DEVELOPMENT APPLICATION ASSESSMENT REPORT

Application Number:	DA2021/1779
----------------------------	-------------

Responsible Officer:	Brittany Harrison
Land to be developed (Address):	Lot B DP 396339, 11 Hilltop Road AVALON BEACH NSW 2107
Proposed Development:	Demolition works and construction of a dwelling house including an attached secondary dwelling and swimming pool
Zoning:	C4 Environmental Living
Development Permissible:	Yes
Existing Use Rights:	No
Consent Authority:	Northern Beaches Council
Land and Environment Court Action:	No
Owner:	Shawn Francis Tranter Siobhan Louise Tranter
Applicant:	Phillip Anthony Byrne

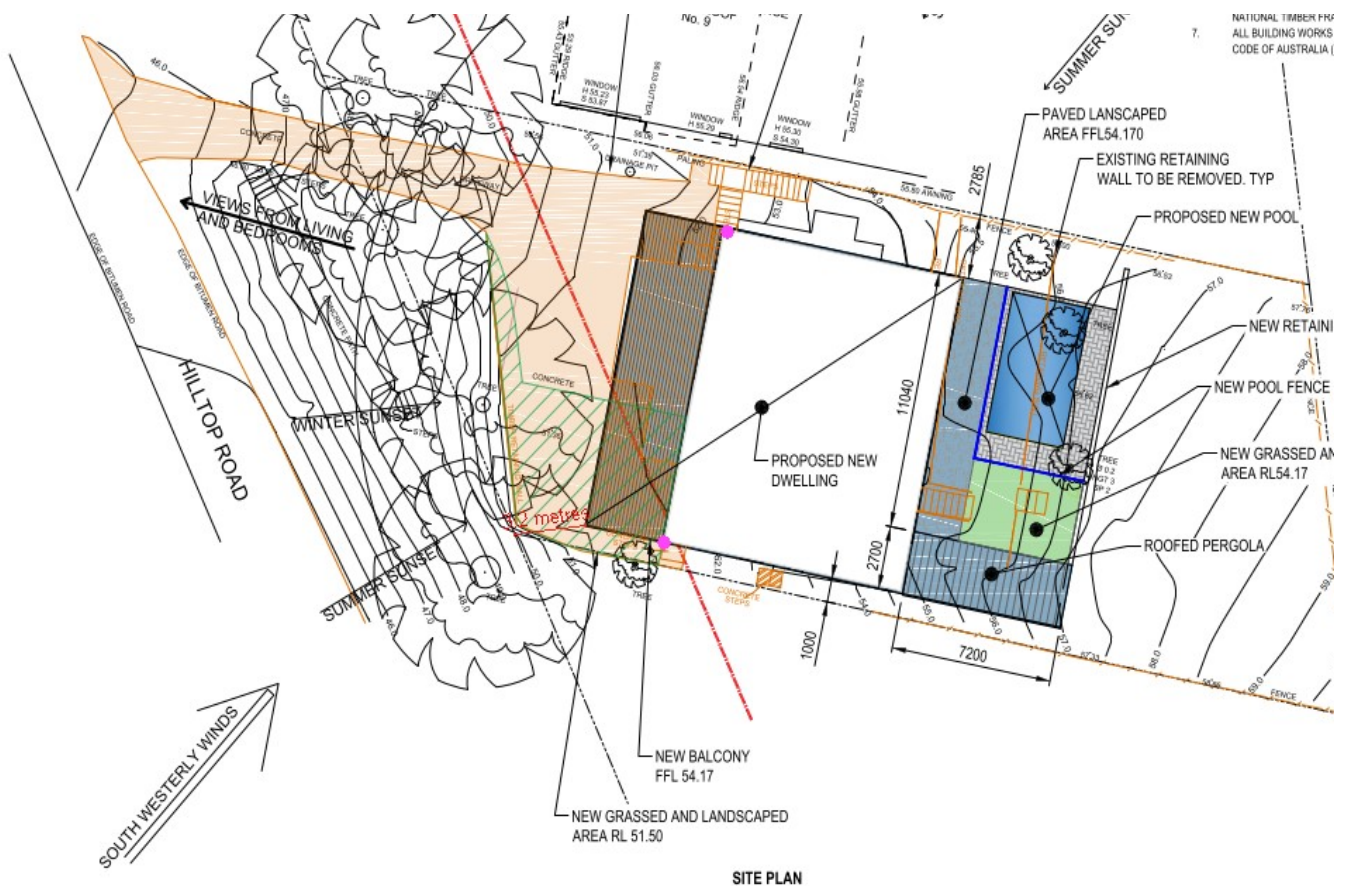
The proposal will involve the transportation of approximately 353m³ of excavated material from the site. Noting that Hilltop Road is particularly narrow, a condition has been imposed requiring a Construction Traffic Management Plan to be prepared and submitted to Council prior to works commencing on site.

Subject to compliance with the conditions of consent, the proposal will be consistent with the outcomes and requirements of this control.
